Minor Amendment of the approved site plan to move two off site ADA accessible parking spaces onsite. These changes affect the approved Site Plan and Landscape Plan.

The purpose of this letter is to request approval of a Minor Amendment to the previously approved Site Plan-DRB (PR-2021-005390 / SI-2021-00832) at 5000 Central Avenue NE. Two ADA-accessible parking spaces were relocated from Jackson Avenue to onsite adjacent to the building at the request of the Mortgage Finance Authority (MFA), one of the two entities (City of Albuquerque Family and Community Services being the other entity) that financed this affordable housing project, which is currently under construction.

HILAND PLAZA

FEBRUARY 16, 2023
MINOR AMENDMENT - ON STREET PARKING SPACES
RELOCATED FROM JACKSON ST. TO THE PROPERTY,
ENTRY GATES SHIFTED NORTH TO ACCOMMODATE
RELOCATED ACCESSIBLE PARKING.

A1 SITE PLAN - DRB

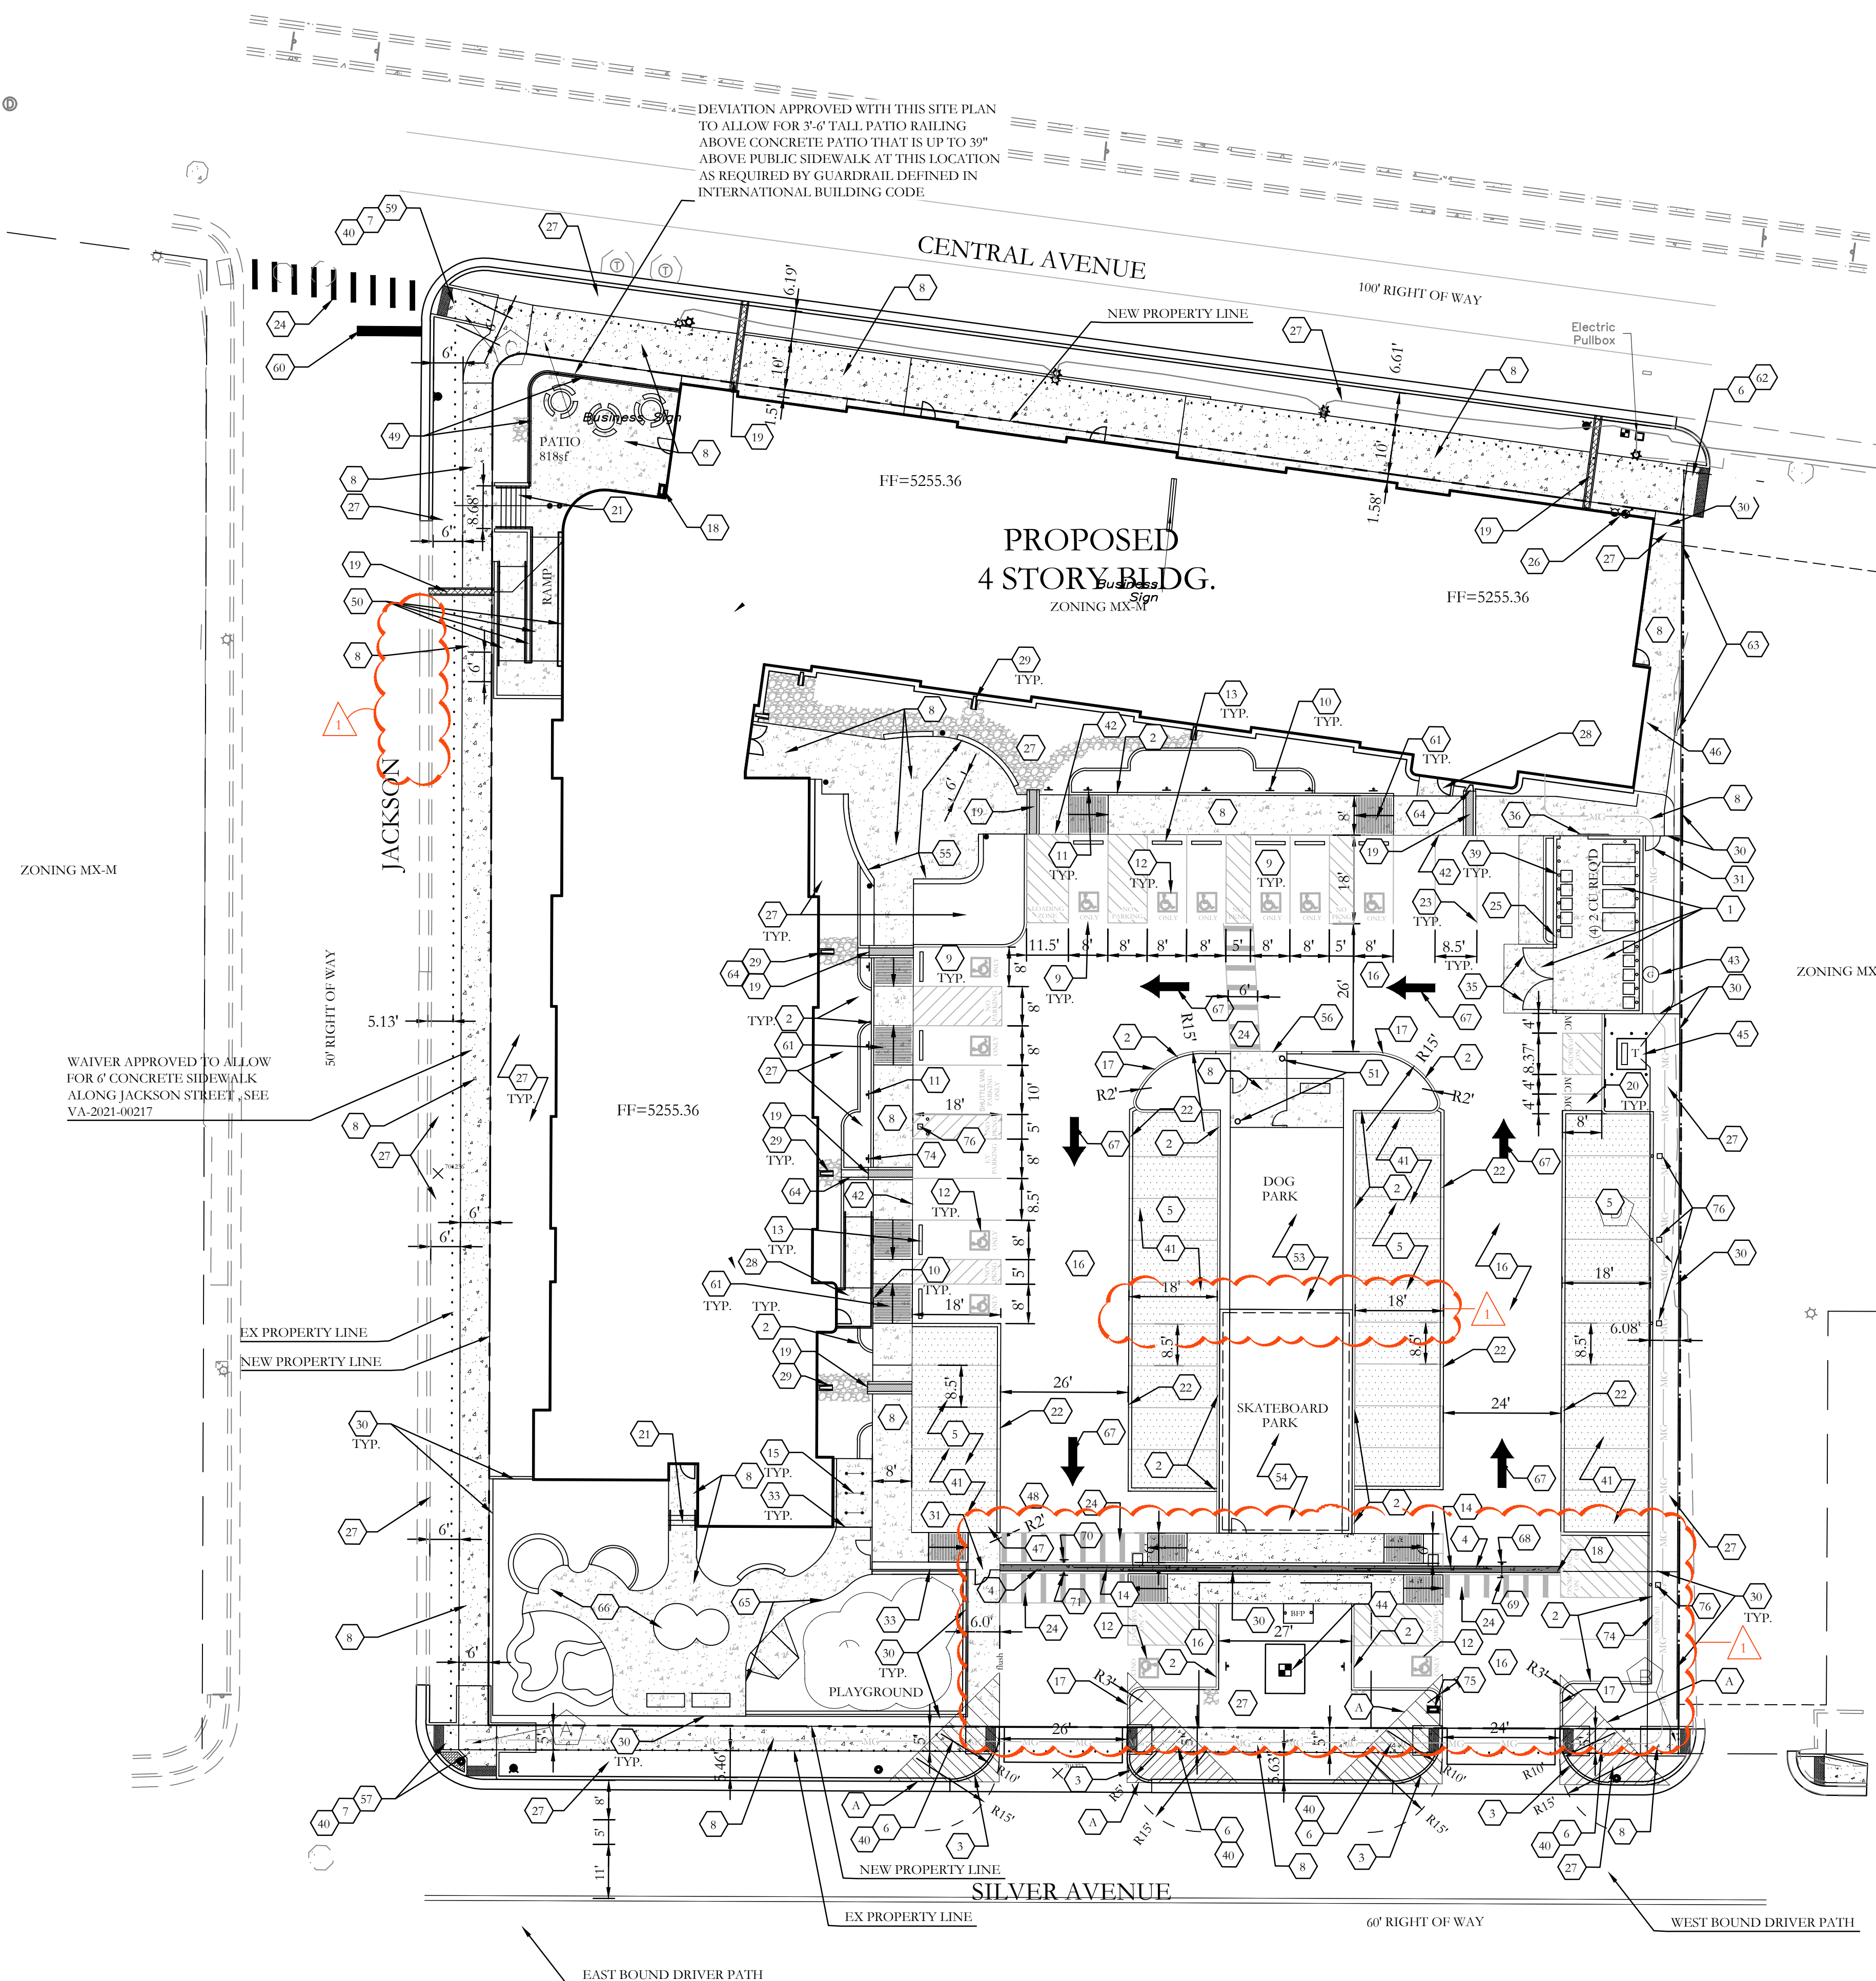
- Two ADA-accessible parking spaces are shown relocated from Jackson Avenue to an onsite location on the south side of the building and the curb access ramp associated with the parking spaces has been removed. Two additional ADA-accessible parking spaces have been added to the south of the building. The parking area was reconfigured to allow for the additional accessible parking spaces. Total onsite parking provided decreased from 62 to 55 and ADA-accessible parking increased from 8 to 12. Both the onsite parking and ADA parking provided exceed the minimum requirement.
- Eight of the parking spaces are designated for electric vehicles (EV).
- The 5-foot-wide opening in the curb was removed between the dog park and the skateboard park.

LANDSCAPE PLAN

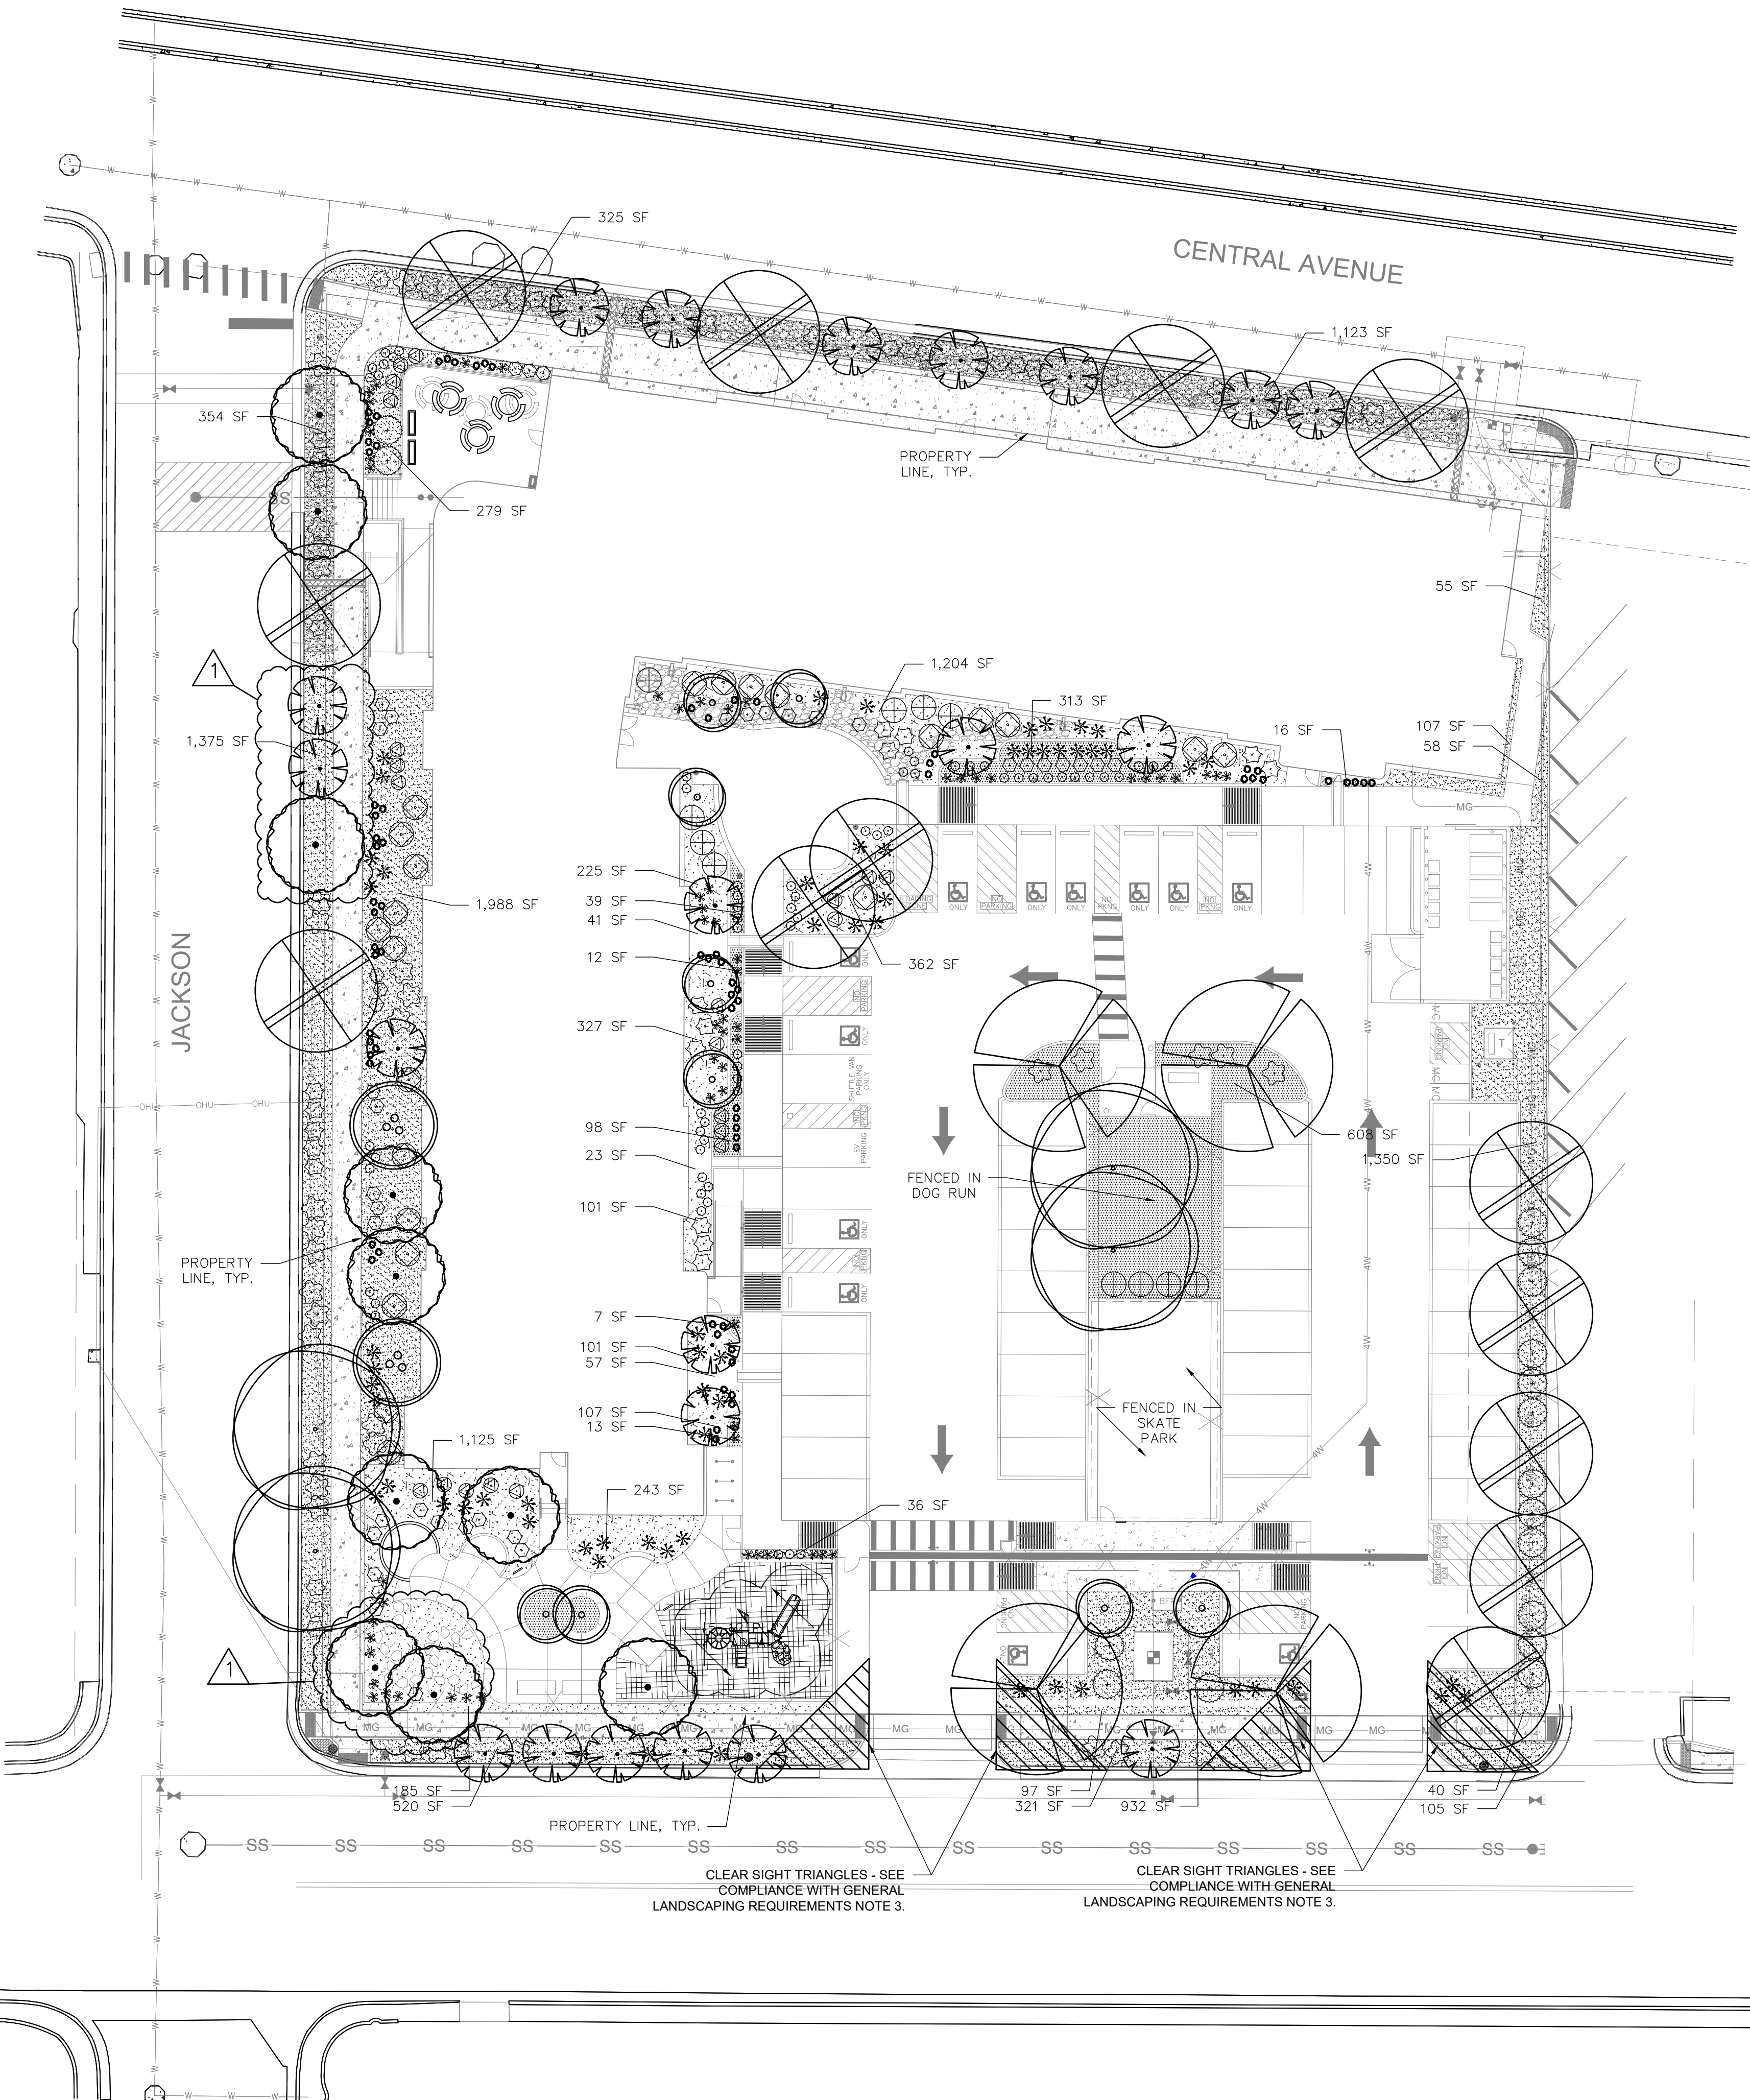
- Responding to required changes to the Site Plan, landscaping was added along the Jackson Avenue curb access ramp location and at the southeast corner of the site.
- The landscape quantities changed moderately and are documented in the Plant Legend.

FEBRUARY 16, 2023
MINOR AMENDMENT
LANDSCAPE PLAN CHANGES PER SITE PLAN
